Lahontan Regional Water Quality Control Board

March 30, 2016

ADDITIONAL INFORMATION REQUEST FOR TECHNICAL MEMORANDUM INVESTIGATION WORK PLAN, PACIFIC GAS AND ELECTRIC (PG&E), HINKLEY COMPRESSOR STATION, SAN BERNARDINO COUNTY (CLEANUP AND ABATEMENT ORDER NO. R6V-2015-0068)

Enclosure 6

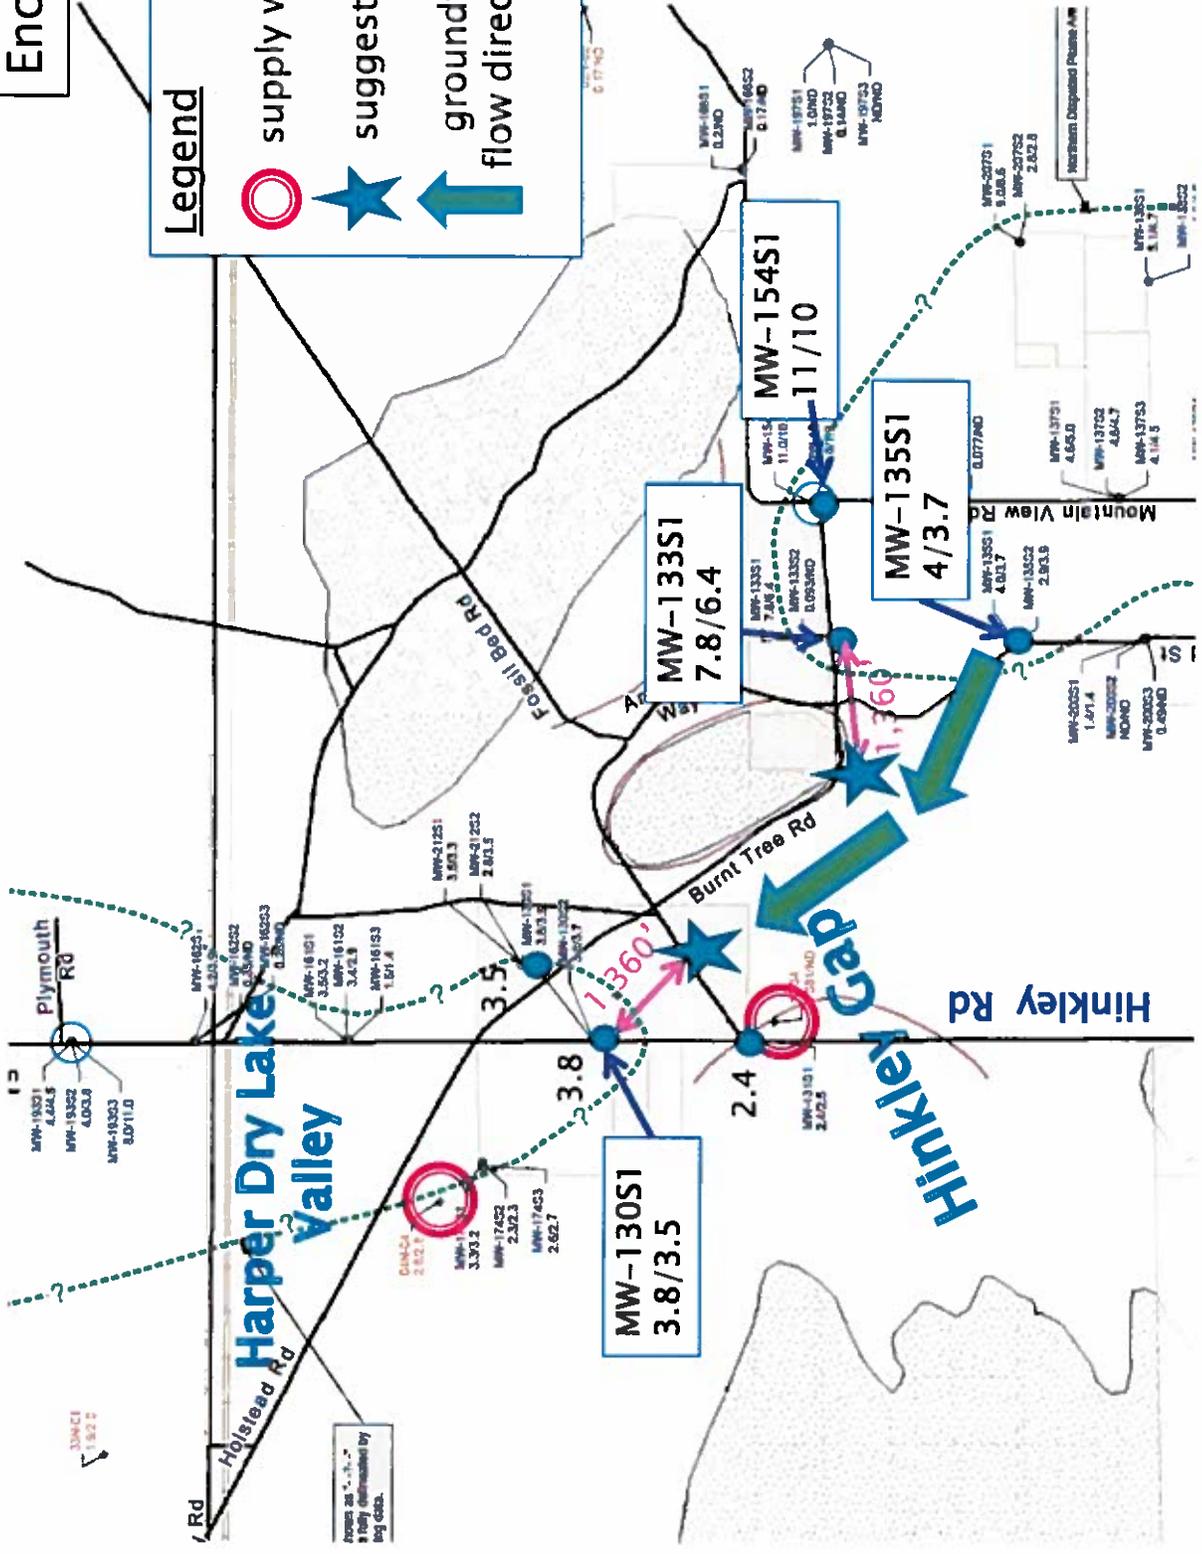
In the Hinkley Gap (Area III), the Work Plan shows the plume boundary of the Harper Dry Lake Valley plume drawn around MW-130 and MW-212, where chromium concentrations greater than 3.1 ppb are detected. However, no new monitoring wells are proposed to define the chromium plume through the Hinkley Gap, which is separated with the northern Hinkley Valley plume by 4,000 feet. PG&E has stated it is inappropriate to compare the chromium results from wells in the Northern areas to the maximum background levels established for areas to the south. The Work Plan recommends waiting until the results of the U.S. Geological Survey's chromium background study are known before conducting further investigations of the chromium plume in this area.

The request to wait until background study results are known in late 2017 is not reasonable since no technical justification has been provided. Since third quarter 2013, data from monitoring wells in this area show increasing concentration trends towards the north (MW-135 to MW-133) and west (MW-154 to MW-133) (Enclosure 6). Specifically, monitoring well MW-133S1 has increased in concentration by 700% since third quarter 2013. Since the northwestern boundary of the northern Hinkley Valley plume is no longer defined, additional monitoring wells or alternate methods to evaluate chromium concentrations are needed to evaluate the threat to domestic well 10-04. This could be accomplished by installing a multi-depth monitoring well on either PG&E-owned land or County Right-of-Way along Burnt Tree Road, west of MW-133. Similarly, better plume resolution is also needed southeast of MW-130 to determine the southeastern plume boundary of the Harper Dry Lake Valley plume. To achieve this goal, a multi-depth monitoring well could be installed on PG&E-owned land, west of the intersection of Burnt Tree Road and Fossil Bed Road. Installation of monitoring wells at the above two locations should be able to reduce the distance between the two plumes by 2,000 feet.

- g. Propose multi-depth monitoring locations west of MW-133 and southeast of MW-130 to sufficiently define the chromium plume through the Hinkley Gap.
